VIRGINIA ELECTRIC AND POWER COMPANY
SUBMITTAL OF APPROVED TOPICAL REPORT DOM-NAF-1-REV. 0.0-P-A
QUALIFICATION OF THE STUDSVIK CORE MANAGEMENT SYSTEM REACTOR
PHYSICS METHODS FOR APPLICATION TO NORTH ANNA AND SURRY POWER
STATIONS

**Qualification of the Studsvik
Core Management System
Reactor Physics Methods for
Application to North Anna
and Surry Power Stations**

Appendix A: RAI Set 1 Questions and Responses**NRC Request for Additional Information (first set) and Responses**

Figure 22

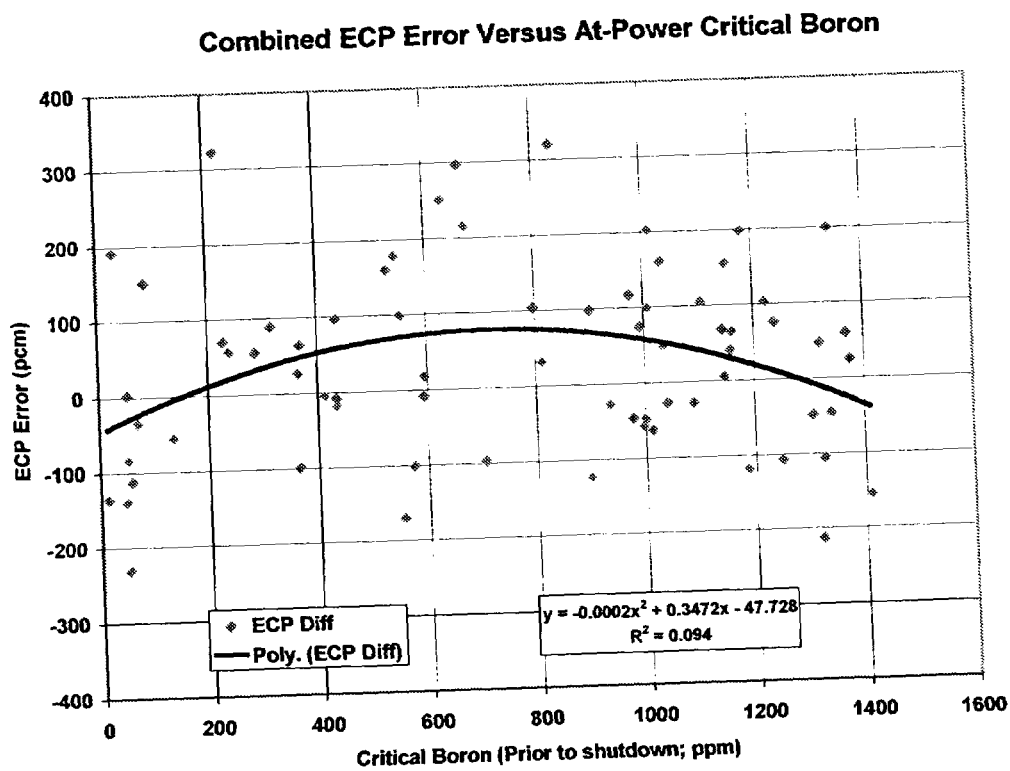
- 7) Figure 22 on page 54 shows significant scatter. Please explain how this data supports your statement that the bias is primarily in the middle of the boron range.

Figure 22 was not intended to demonstrate a strong correlation between boron concentration and ECP error. In fact, no correlation with boron is expected except that which results from the mis-modeling of ECP conditions due to B^{10} depletion. Figure 22 was included to show that a portion of the ECP data scatter is probably due to B^{10} depletion rather than SIMULATE uncertainty. However, for simplicity, all of the data have been included in the determination of the ECP statistics in Table 10.

B^{10} depletion introduces mis-modeling because the measured boron before the ECP can have a different B^{10}/B^{11} ratio than the measured boron at the time of the ECP return to critical. SIMULATE boron predictions are based on a constant B^{10}/B^{11} ratio. The reactivity comparison between measurement and prediction is skewed by the B^{10}/B^{11} difference. Although it is possible to correct for this mismatch, the process involves a great deal of measured data and was not practical due to the large number of cycles modeled.

B^{10} depletion mis-modeling is most likely to occur at mid cycle, during which boron concentration tends to be in the middle of the range shown in Figure 22. The bow in the fit is consistent with the expected influence of uncorrected B^{10} depletion on an ECP. The point in demonstrating this is to show that B^{10} depletion tends to increase the scatter in the ECP data (introduces a positive bias for certain cases but not for others)

Figure 38

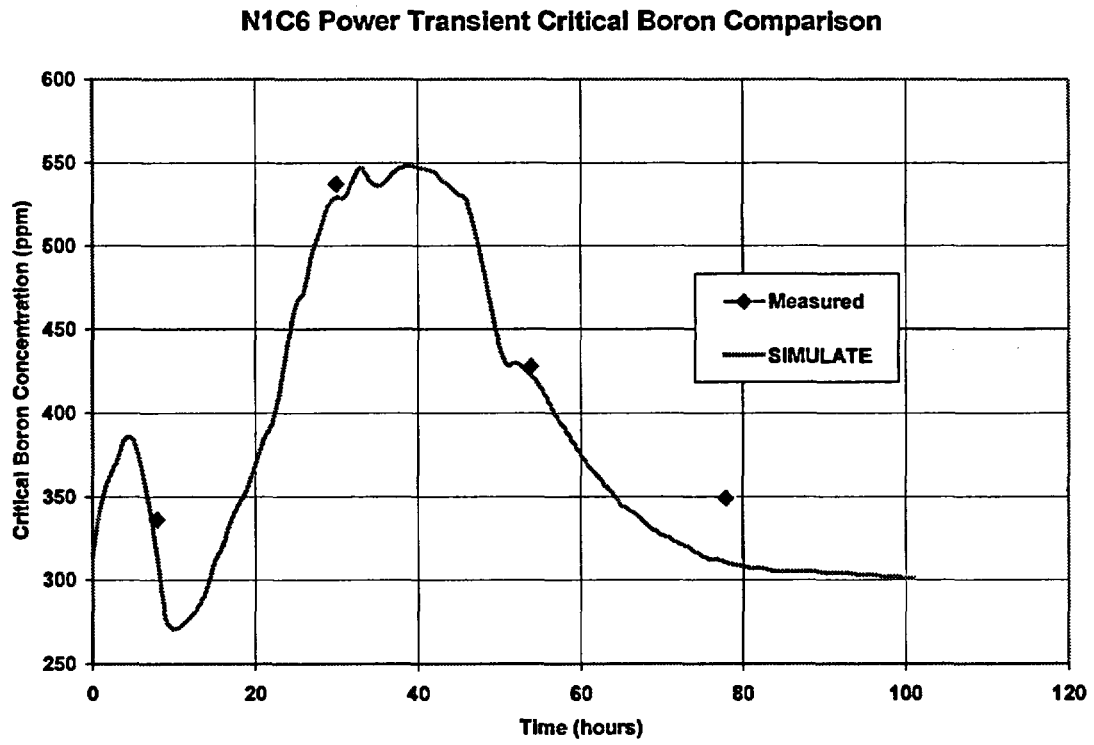
- 10) On page 75, you indicate that the Figure 38 SIMULATE boron values followed the measured values within about +18/-15 ppm. However, you only provide 4 data points for comparison purposes during the power transient. Describe how SIMULATE accurately models this transient given the limited data. Additionally, describe why the +18/-15 ppm assessment is accurate.**

There are only four critical boron data points available for the N1C6 transient. The "+18/-15" comment indicates the range of difference (P-M) for those four points after accounting for the initial difference at the beginning of the transient. These results are consistent with the body of data from the other transients and consistent with the critical boron NRF. The good agreement between predicted and measured delta-I data is the best evidence of modeling accuracy for this transient.
